LEWIS COUNTY PUBLIC SAFETY BUILDING PARKING LOT AND DRAINAGE PROJECT

REVISIONS		
NUMBER	DESCRIPTION	DATE
△	ADDENDUM #1 - SEE INDIVIDUAL SHEETS FOR ALTERATIONS	05-11-2023

2023-003 - MAY 3, 2023
LEWIS COUNTY PUBLIC SAFETY BUILDING
PARKING LOT AND DRAINAGE PROJECT
VILLAGE OF LOWVILLE, LEWIS COUNTY, STATE OF NEW YORK

LAST REVISED: 05-11-2023
CONSTRUCTION DOCUMENTS
DRAWING NO. **C101**

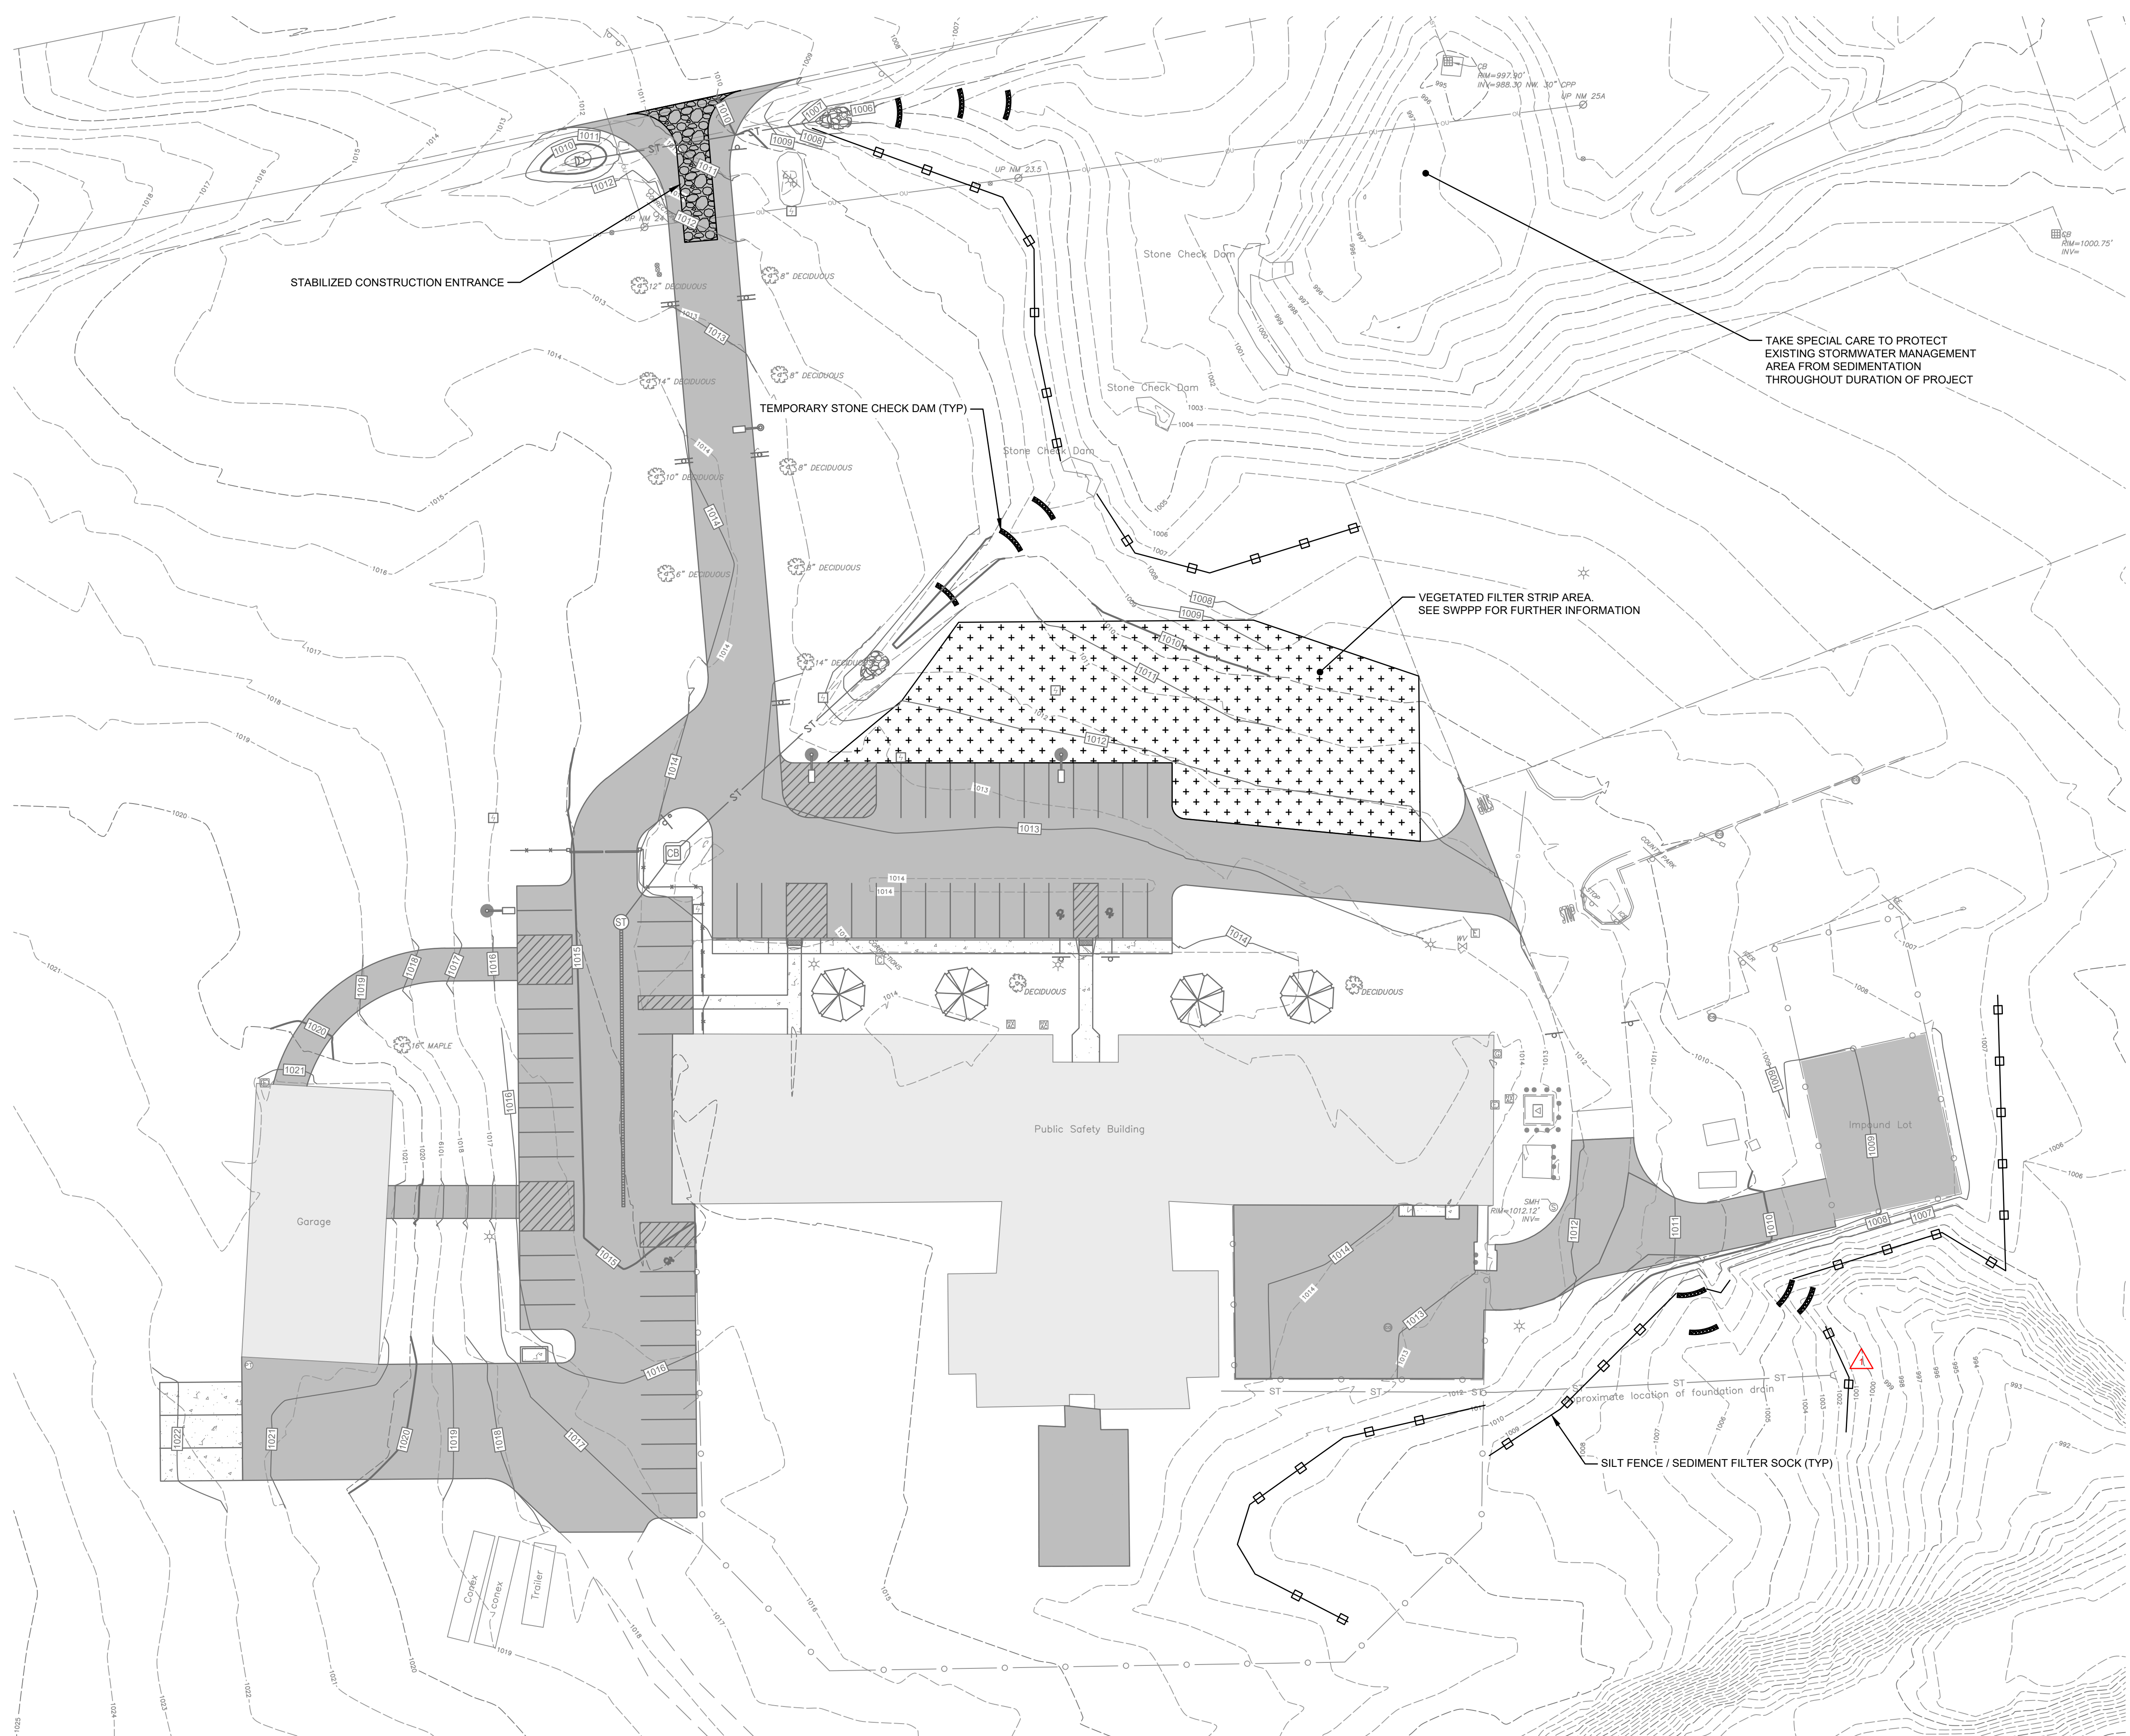
REVISIONS		
NUMBER	DESCRIPTION	DATE
1	ADDITION OF APPROXIMATE FOUNDATION DRAIN LOCATION	05-11-2023

DRAWING NO. **C102**

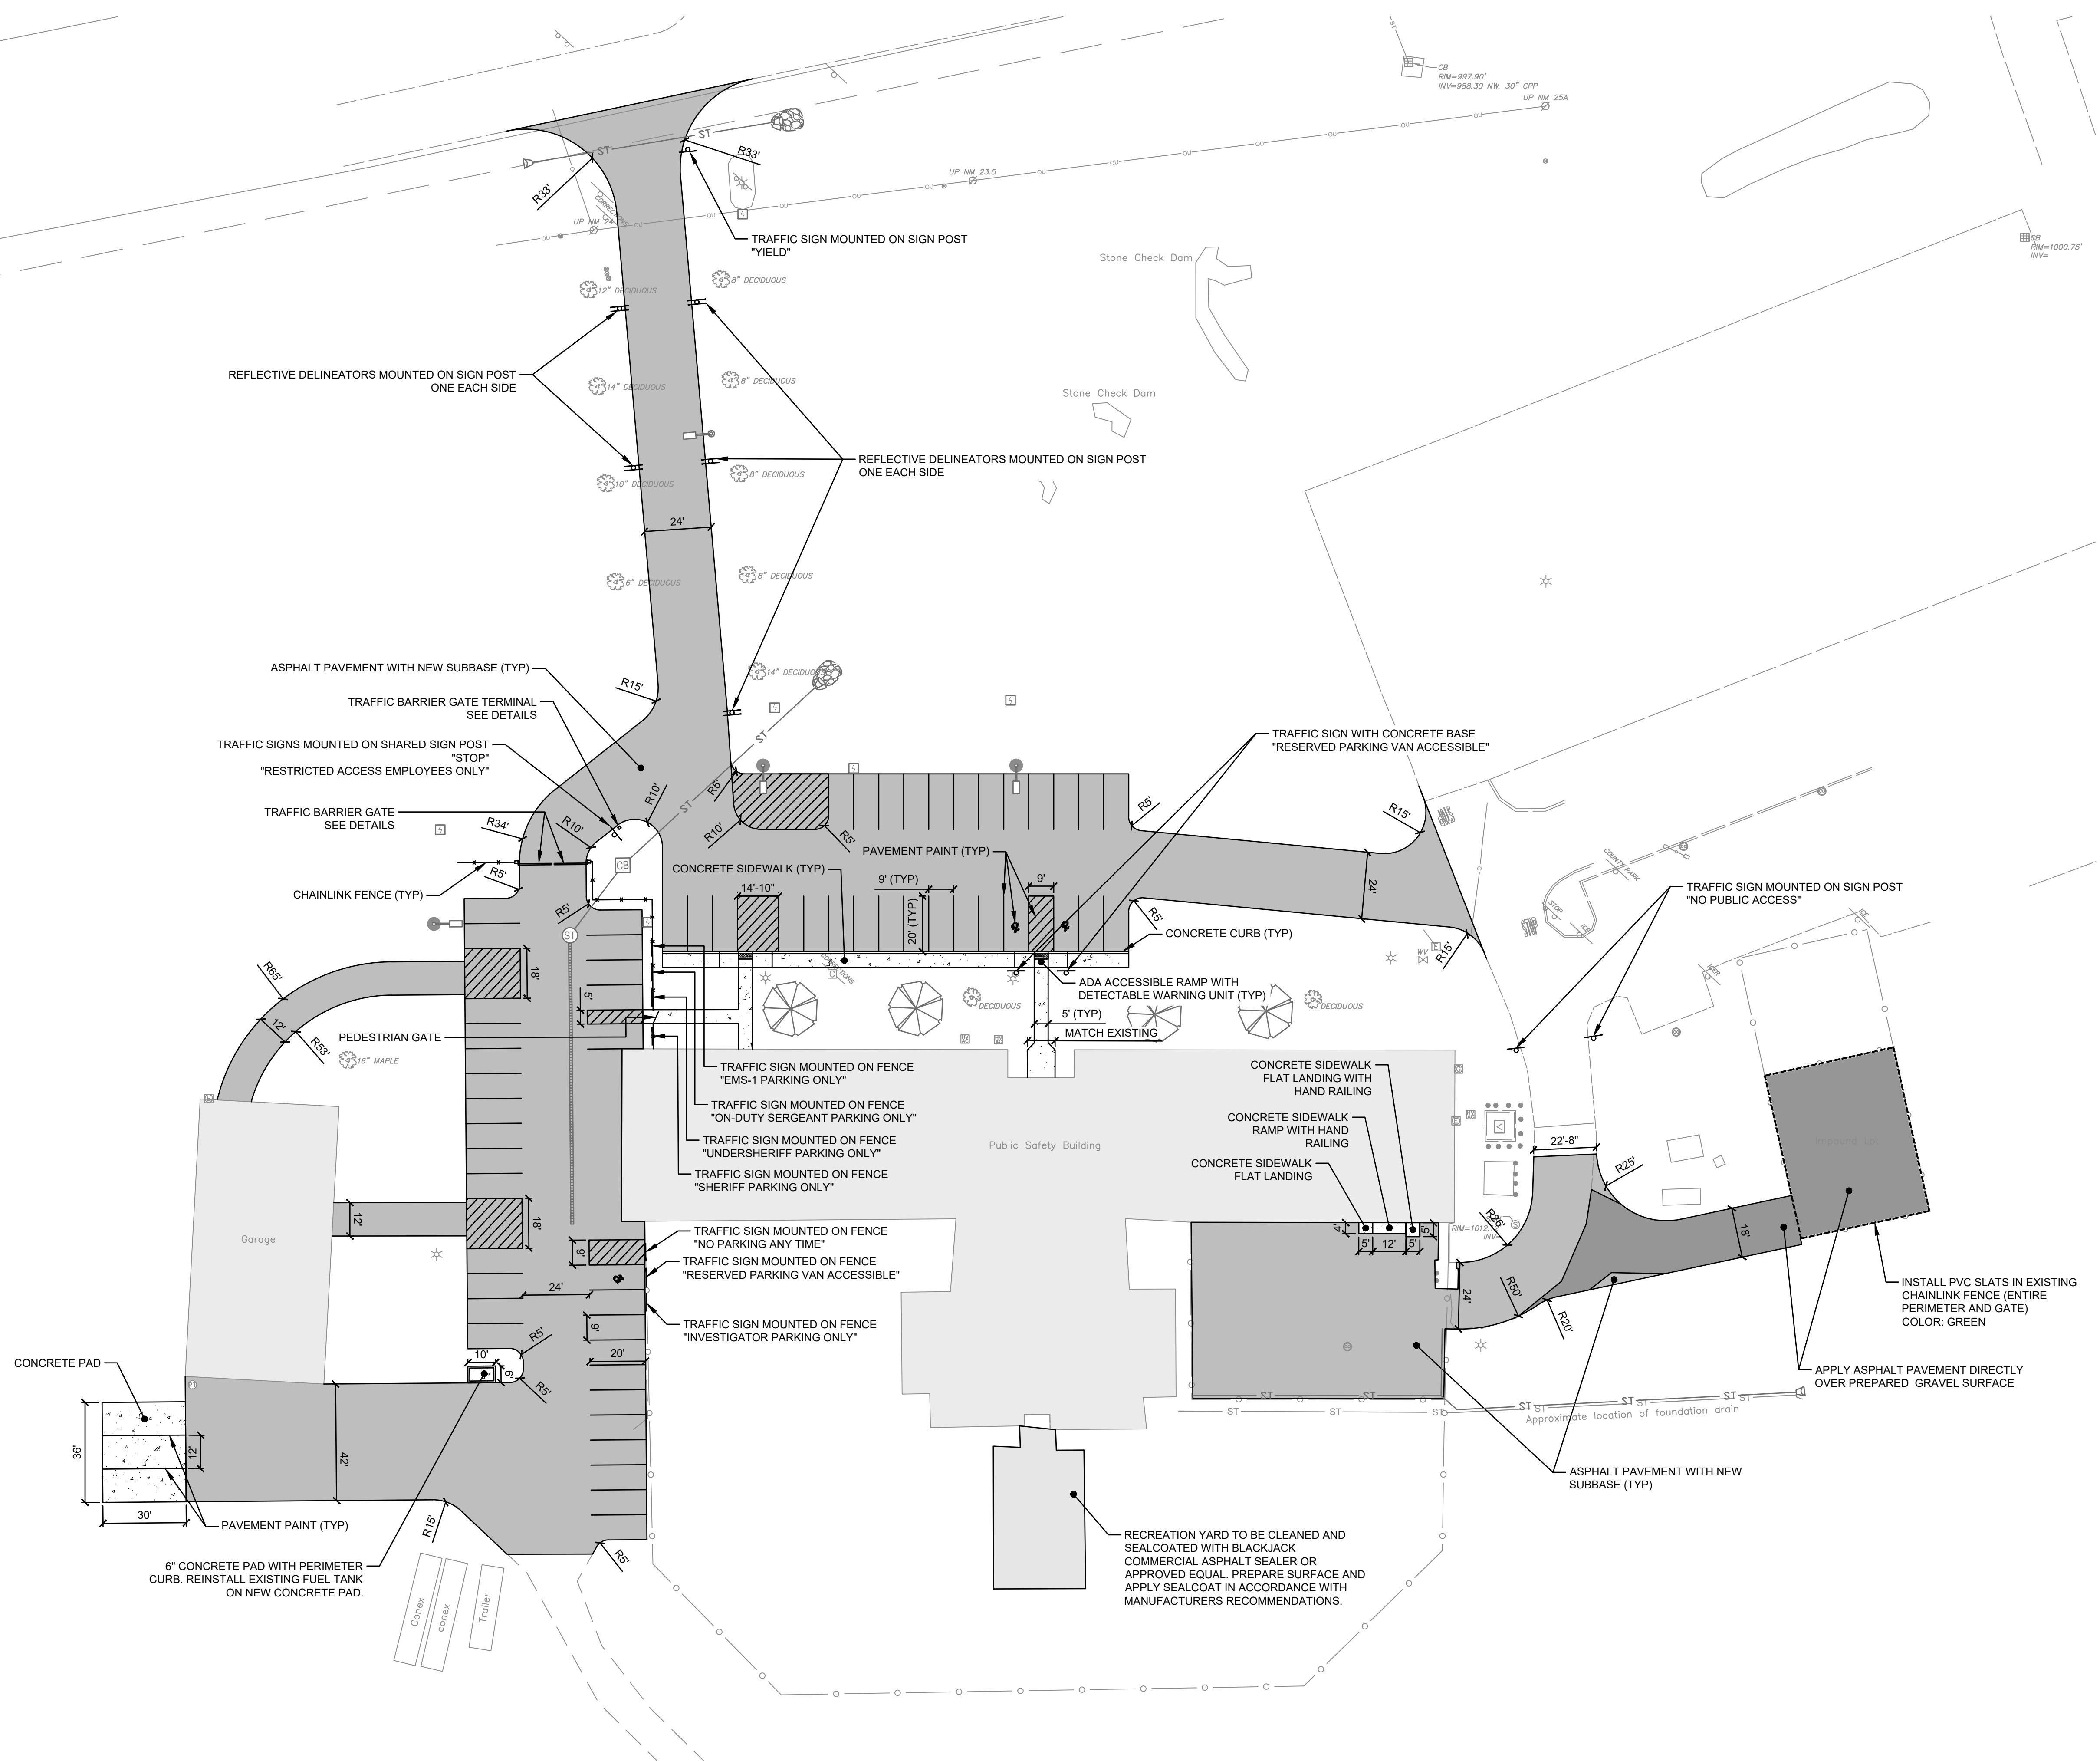
REVISIONS		
NUMBER	DESCRIPTION	DATE
1	ADDITION OF SILT FENCE FOR SALLYPORT UNDERDRAIN INSTALLATION	05-11-2023
